# Initial Solids Removal Plan

**Rico-Argentine Mine Site – Rico Tunnels  
Operable Unit OU01  
Rico, Colorado**

**Responses to EPA Comments<sup>1</sup>**  
**on**  
**Initial Solids Removal Plan Submitted May 2, 2011**  
**by**  
**Atlantic Richfield Company**  
**July 7, 2011**

### SECTION THRU CONCEPTUAL INTERIM DRYING CELLS

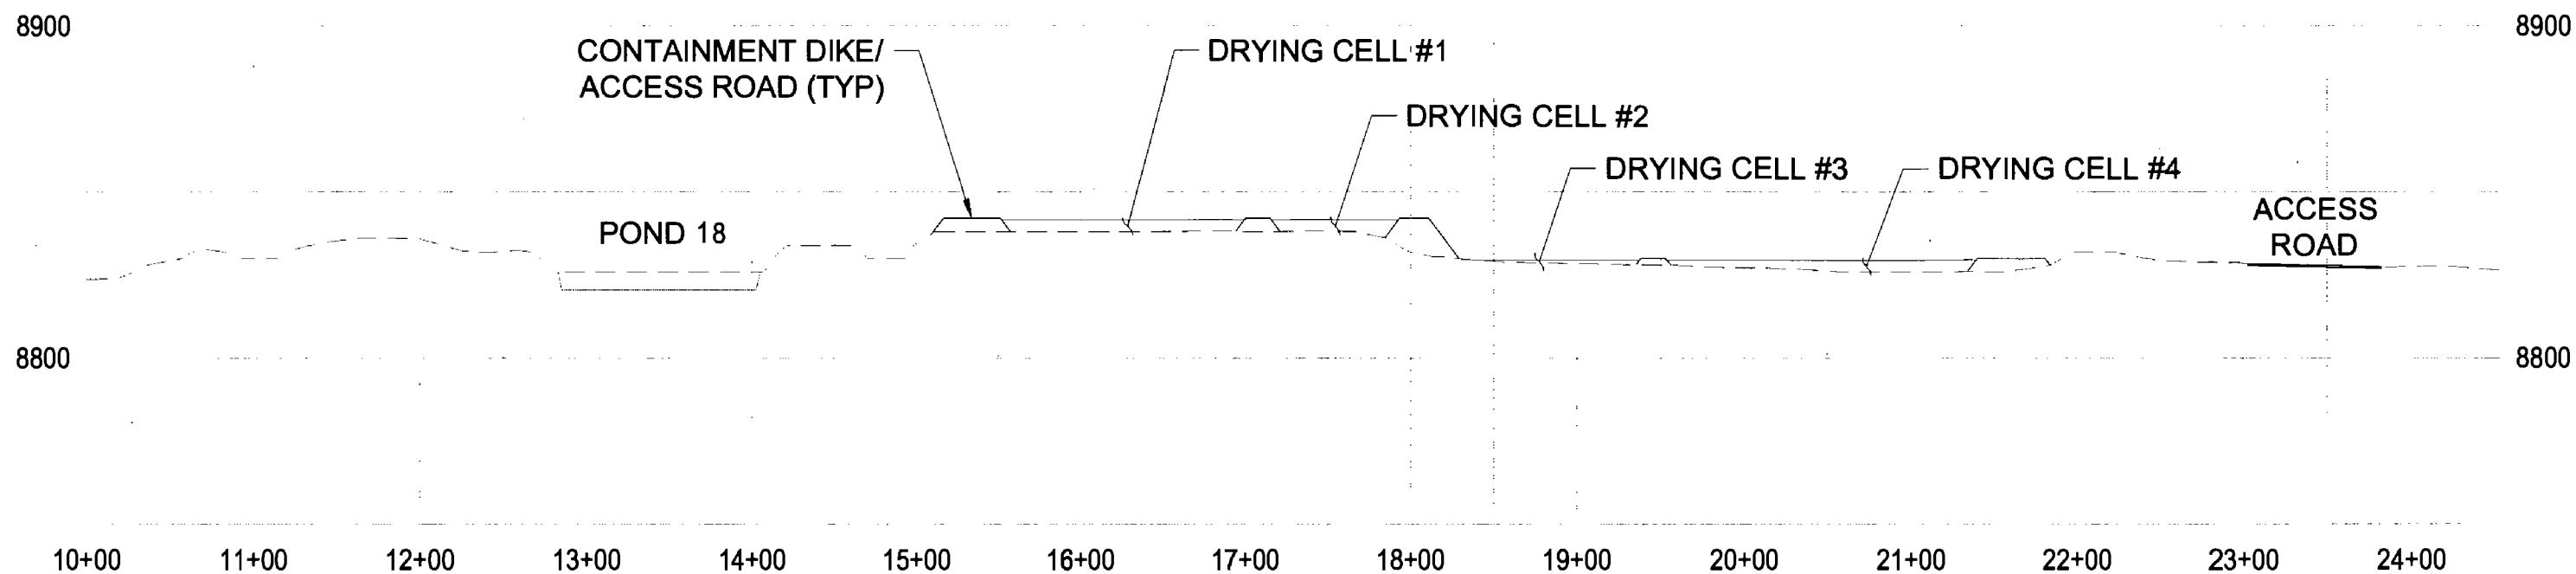
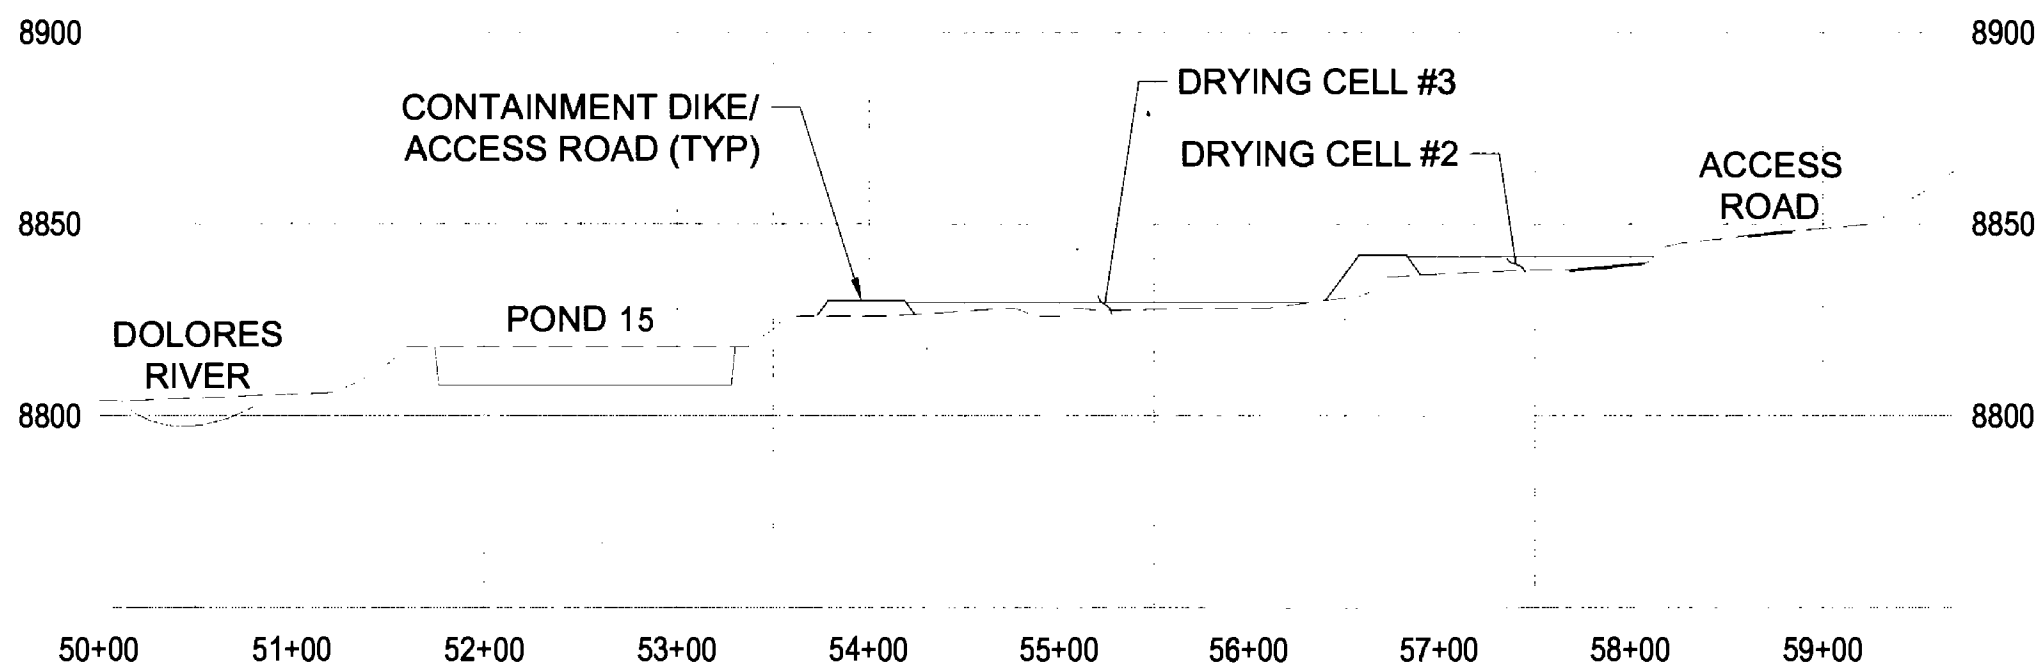
**COMMENT:** The depiction in this draft plan of the water level relative to the bottom of the proposed drying cells raises concerns, and it is of interest and should be monitored. It is understood that the water level data shown was projected from wells not in the immediate area.

**RESPONSE:** See discussion of groundwater levels and conditions in Section 3.2 and Section 3.3 of the revised Initial Solids Removal Plan (ISRP) dated June 30, 2011.
